NM1 - 9

GENERAL CORRESPONDENCE

RE: Modification of OCD Rule 711 Permit
Sunco Water Disposal Facility
San Juan County, New Mexico

Re: Sunco Trucking and Water Disposal (STWD), Case No. 9955; Report entitled "Oxygen Demand Requirements for Sunco Produced Water Facility", dated July 14, 1992: Request that construction at the subject facility be halted

**OXYGEN DEMAND REQUIRMENTS
FOR
SUNCO PRODUCED WATER FACILITY**

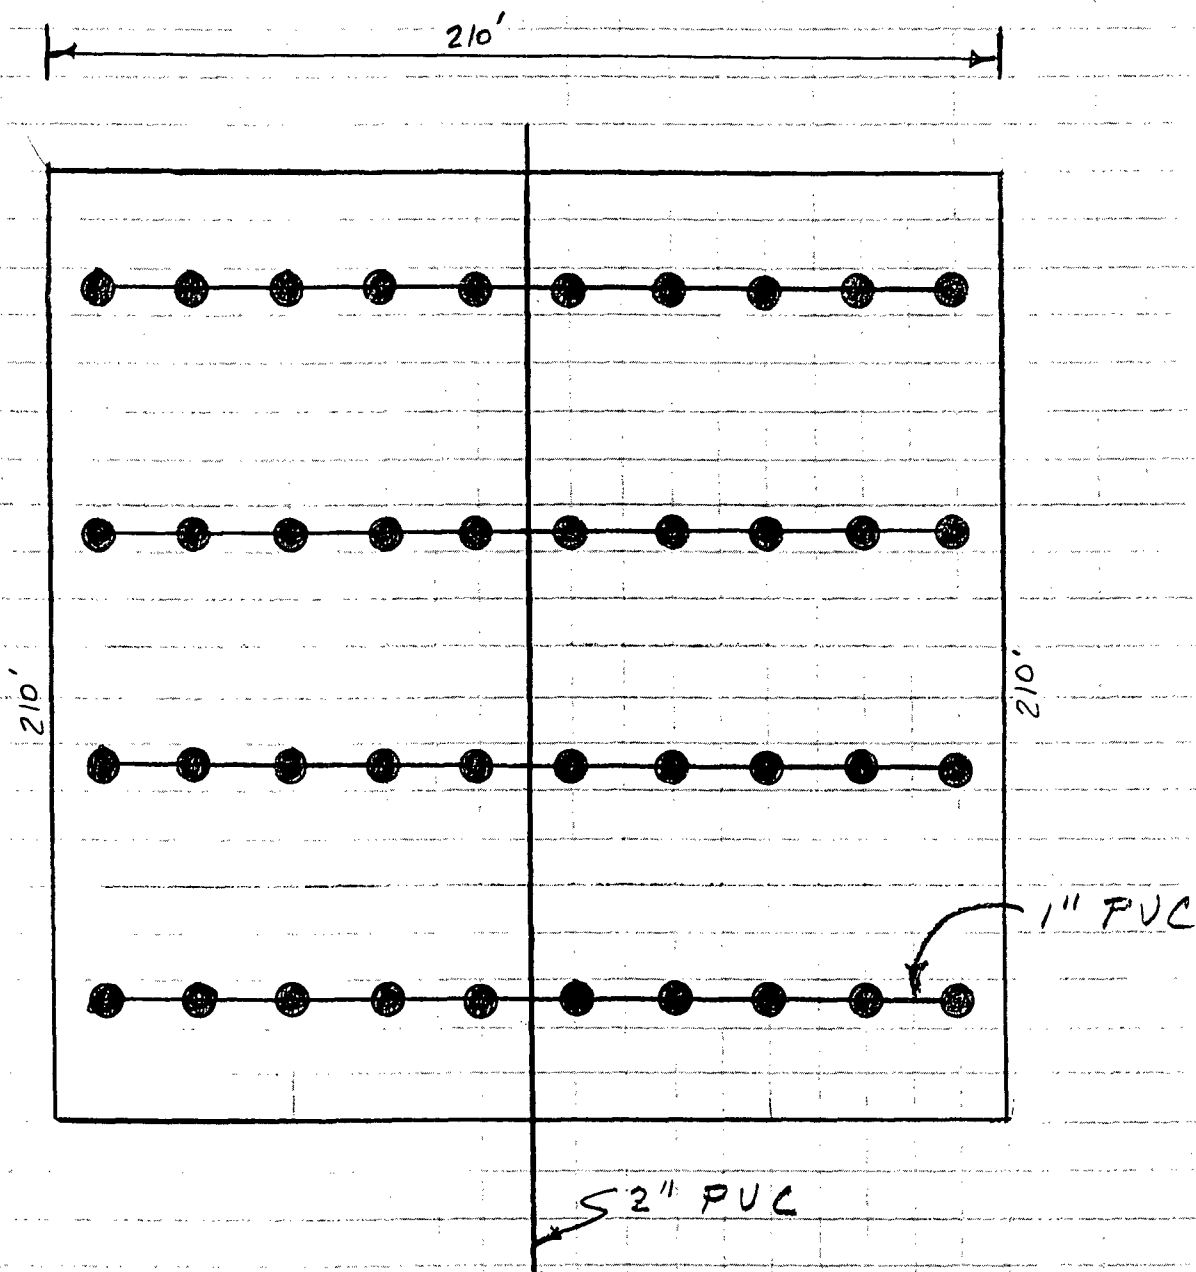
The subject Oxygen Report should not be considered an engineering design for an aeration system. Although the subject Oxygen Report does provide a simple schematic representation of a distribution system, no pump, blower or compressor designs are calculated or otherwise specified. Likewise, no installation or construction details or drawings have been provided.

The subject Oxygen Report indicates that the distribution system laterals will be approximately 50 feet apart. Groups of eight holes along each lateral will apparently be located approximately 20 feet apart along each lateral. The subject Oxygen Report contemplates a total of 320 holes across the 44,100 square foot pond bottom (1 - 3/16 inch diameter hole per 138 square feet) (90,000 square foot surface area; 1 - 3/16 inch diameter hole per 281 square feet). It is very difficult to comprehend that even minimum water velocities can be maintained in the vast majority of the 20,000,000 gallon pond.

Mr. Cheney testified that bubblers in the aeration system would become clogged over time resulting in a significant decrease in efficiency. (June 15, 1990 Transcript, page 268, line 22 through page 269, line 24 and June 12, 1991 Transcript, page 188, line 24 through page 189, line 24.) In fact, a quantification of the problem can be seen from the subject Oxygen Report. Said Oxygen Report states that at a pressure of approximately 100 pounds per square inch (psi), the subject coarse bubble diffuser system could provide 600 cfm using orifices of 3/16 inch diameter. However, if such orifice size were reduced to 1/8 inch, the air flow would be reduced to 275 cfm, and if such orifice size were reduced to 1/32 inch, the air flow at 100 psi would be reduced to 17.25 cfm.
